Hydrology Comments Meeting Minutes

Van Bibber Creek Major Drainageway Plan

Thursday, April 30, 2020

Credit: September 11-13, 2013 Arvada Flood Event: Reconstruction and Documentation. Water & Earth Technologies. March 2014.

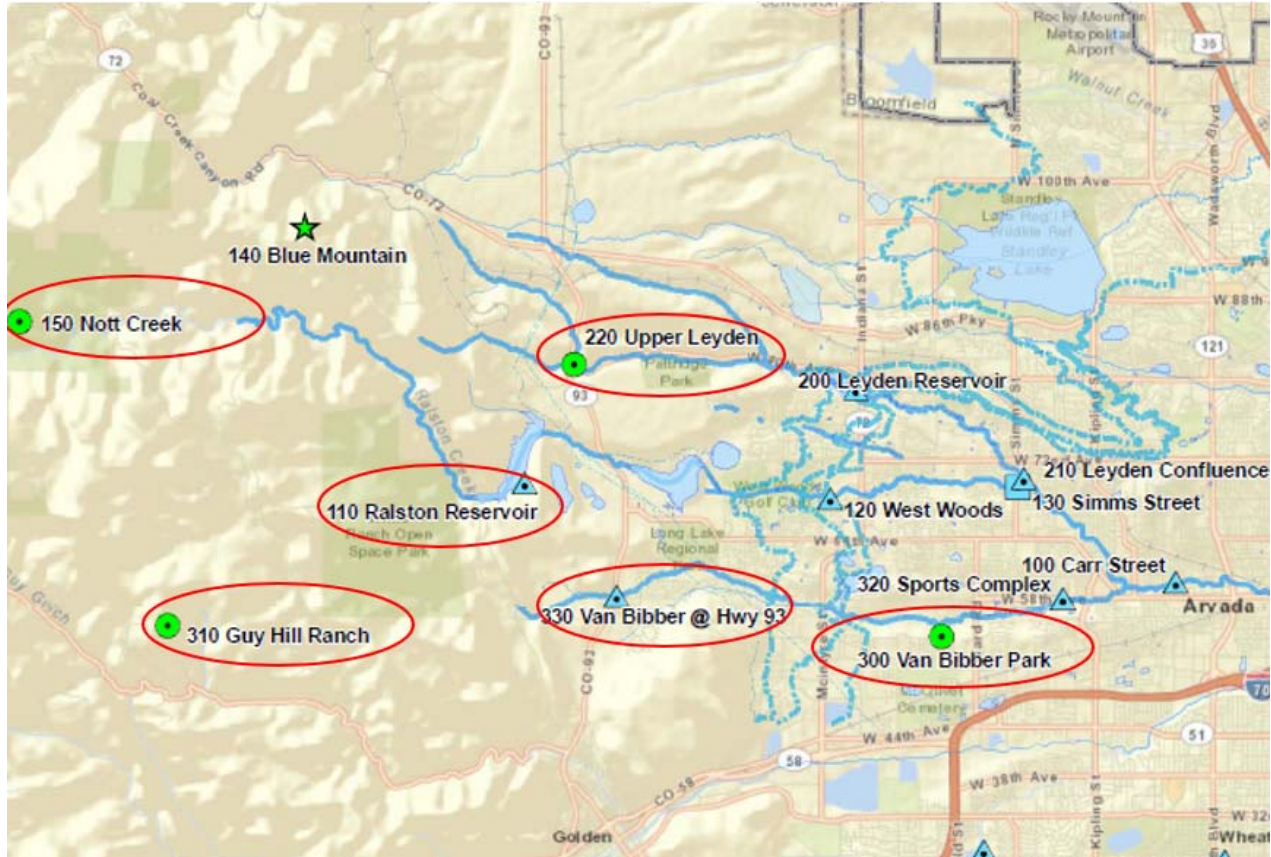
Kevin mentioned that not all of the peak flows listed in Table 4 are accurate. The 2013 flood event has been studied in depth and will be used to help calibrate flows.

NOAA Atlas 14 IDF Curve and September 2013 Flood Event Data from Alert5:

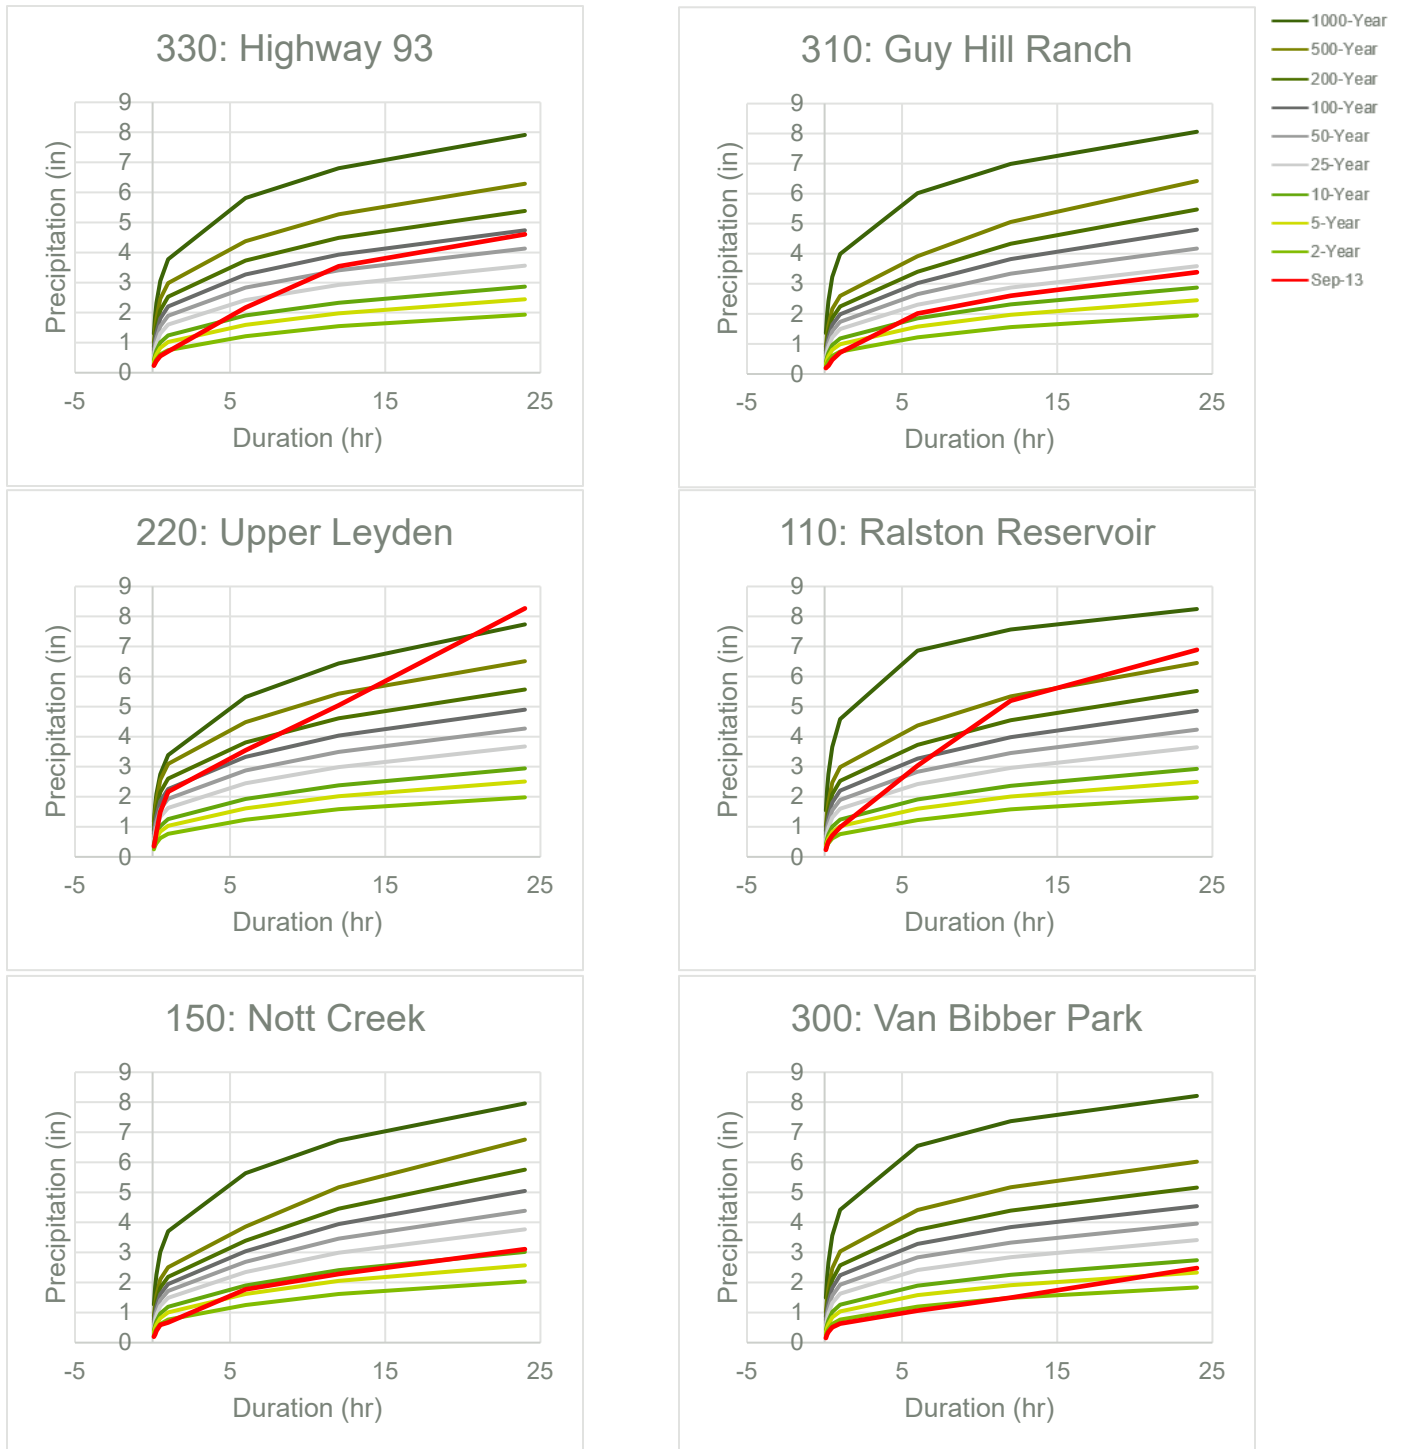
Olsson will use GARR data and the September 2013 flood data to calibrate the upper watershed on Van Bibber Creek. Following the meeting, Olsson discussed with MHFD and it was decided to start the calibration using the single basin upstream of Highway 93 CUHP model. Olsson will then evaluate the lower watershed peak flows to determine whether the increases are justified, or if additional calibration is needed.
